Old Conway Design
Overlay District

DESIGN REVIEW BOARD MEETING

MUSLIM CENTER OF CONWAY OCDR

Muslim Student Center Review

North Elevation

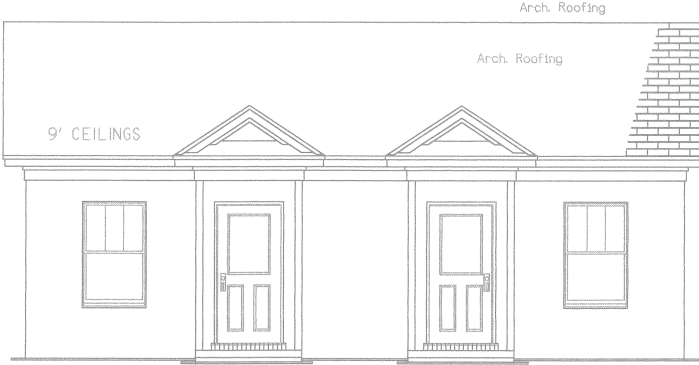
Orientation: The direction in which the front of a building faces. The entrance to the worship building will face the east towards the school. A gabled elevation is presented to South Boulevard. As the primary facade, this elevation might need a bit more detailing.

structures are minimal in detailing but do have a degree of traditional trim work. The columns on the rear cottage and rear portico of the primary structure are too spindly. They appear to be 4 inches square. These columns should be trimmed to be at least 6 inches square. The proposed detailing is appropriate. If the South Boulevard facade is seen as too blank, a braced roof structure could be required to add more facade detail. A sketch is enclosed.

10. Columns on the rear of the primary structure and the front of the duplex shall be a minimum trimmed dimension of 6 inches.
11. Additional braced roof structures as sketched shall be added to South Boulevard facade.

Worship Center Floor Plan

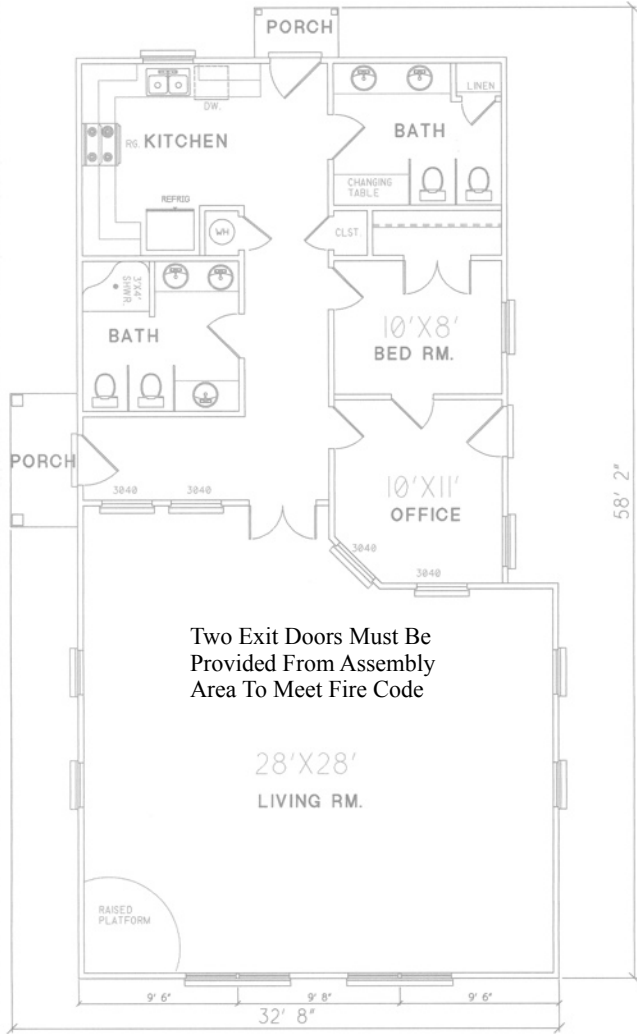
Facade, wall area, rhythm: Facades shall be compatible with surrounding historic structures in proportion of wall to opening area. Window and door openings should correspond to the rhythm and proportion on existing structures. Generally doors and windows should be proportioned in a range of 25-40% of the total surface area. The primary structures front, rear, and west elevations show windows and doors that meet the 25% proportion. The east elevation does not meet the 25% minimum requirement. However, a bathroom and kitchen with cabinets and stove make additional windows difficult. The rear cottage does not show any windows on the east, west, or south elevations. As studio efficiency apartments, windows could limit furniture placement, however one additional window could be placed on the east and west elevations and a small window could be placed above the sink in the kitchen areas.

Doors and windows: The style and proportion of the windows and doors as shown are appropriate. As stated above, additional windows in blank facades should be considered.

8. Finished first floor elevation shall be a minimum of 18 inches above grade. Floor to ceiling height shall be 9 feet.
9. Additional windows and doors shall be required as shown on enclosed floor plan.
